**Lichterman Nature Center Major Maintenance – Phase 1**

**Addendum No. 1**

Name: Lichterman Nature Center  
Major Maintenance – Phase 1  
A2H #: 21513

Addendum #: 1  
Date of Issuance: 4/29/25  
Sent Via: Email  
Total Pages: 26

TREES TO BE REMOVED		
COUNT	DBH	TYPE
2	8"	CEDAR
1	14"	DEAD
1	12"	SWEET GUM

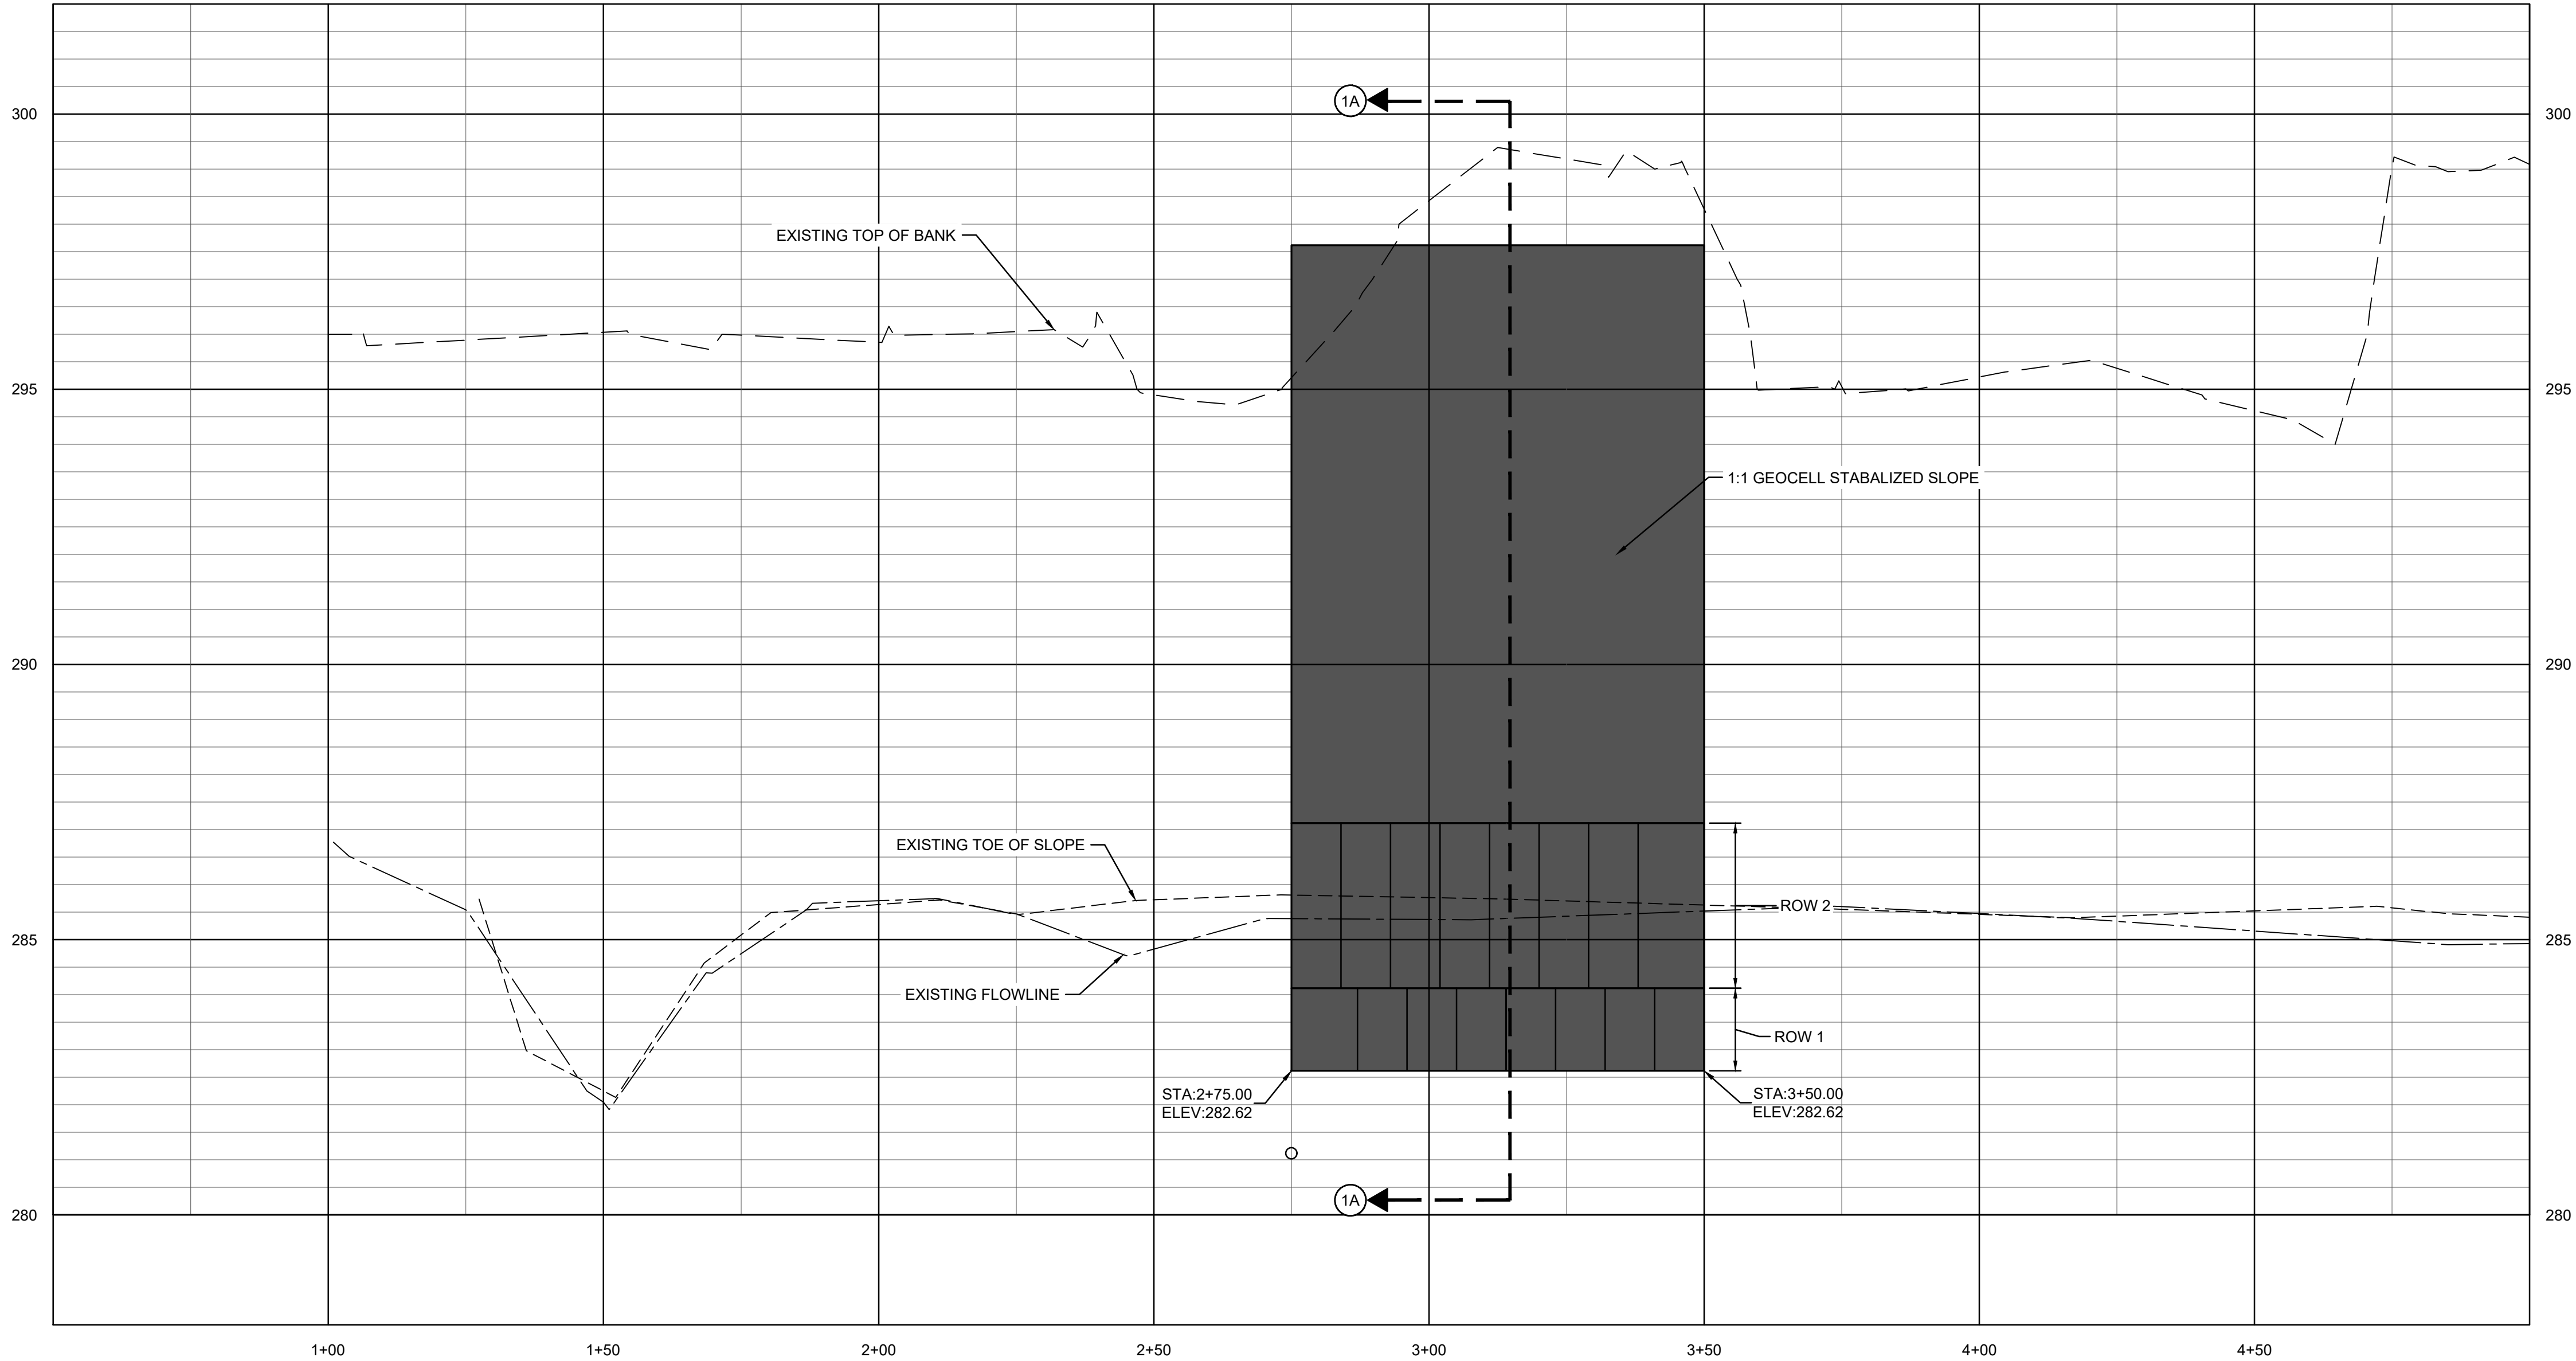
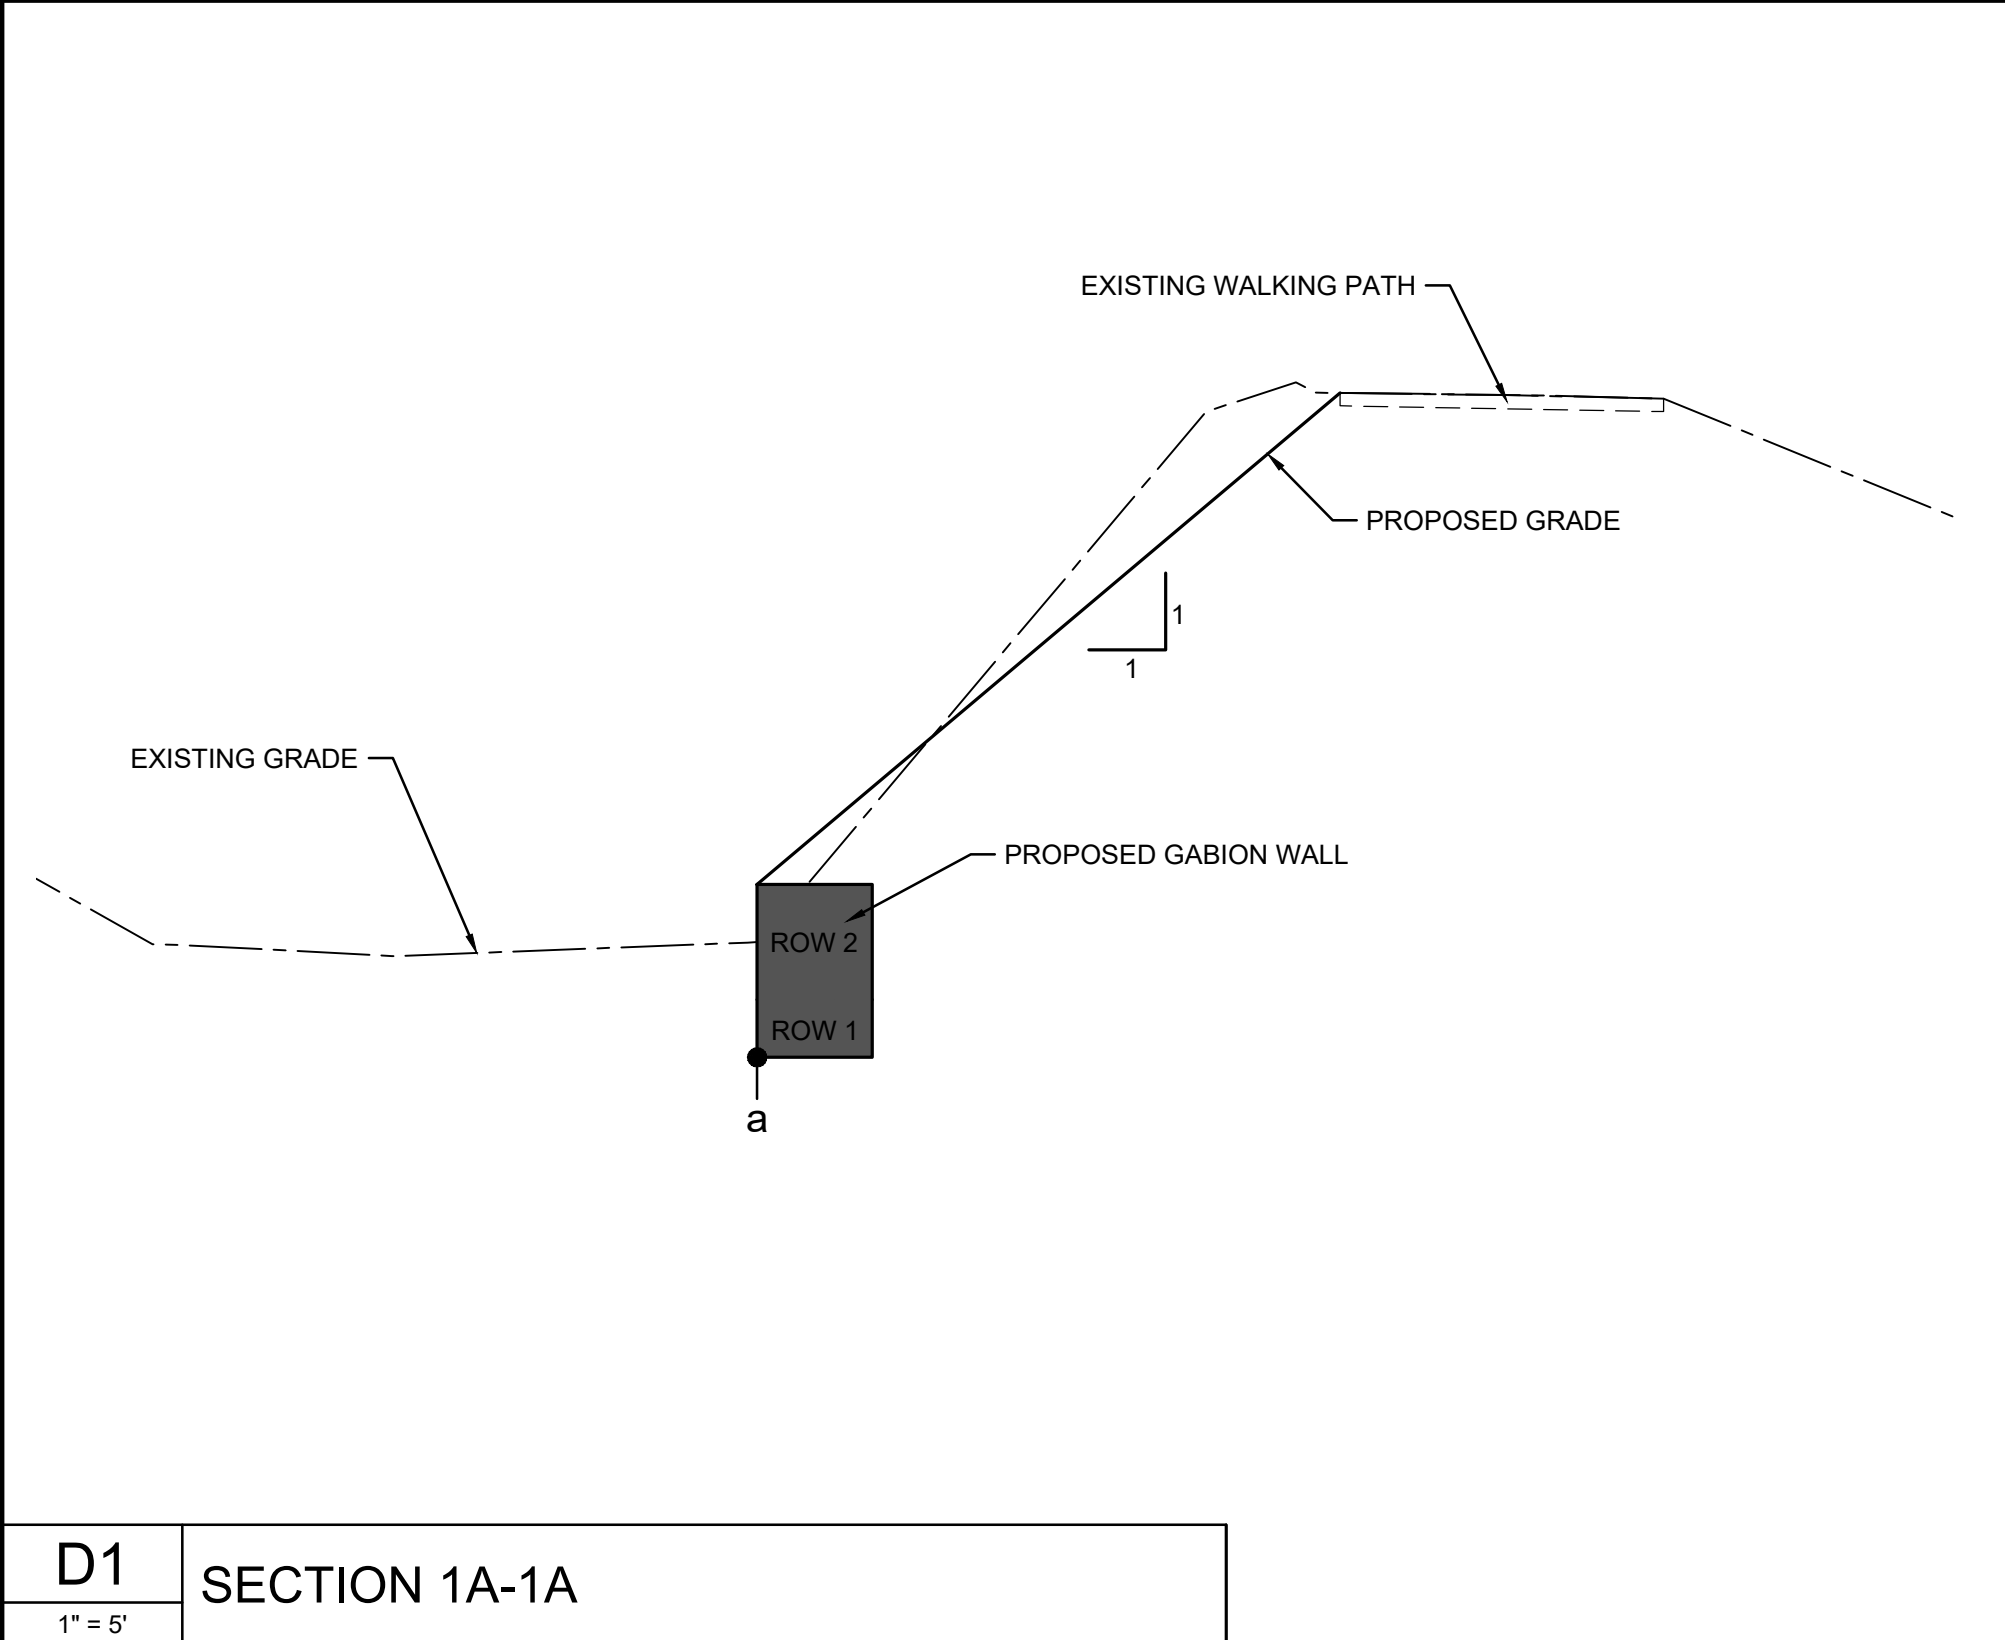
- *Yes. There is an existing system that can lower the lake level but will need to see if it is operational.*
6. Review the existing trees to be removed since the redesign of the stream.

- *See revised Sheet C5.1 attached to this addendum.*
7. With the bridge being removed, is there anything being provided to let pedestrians know the trail dead-ends and is barricade be provided?
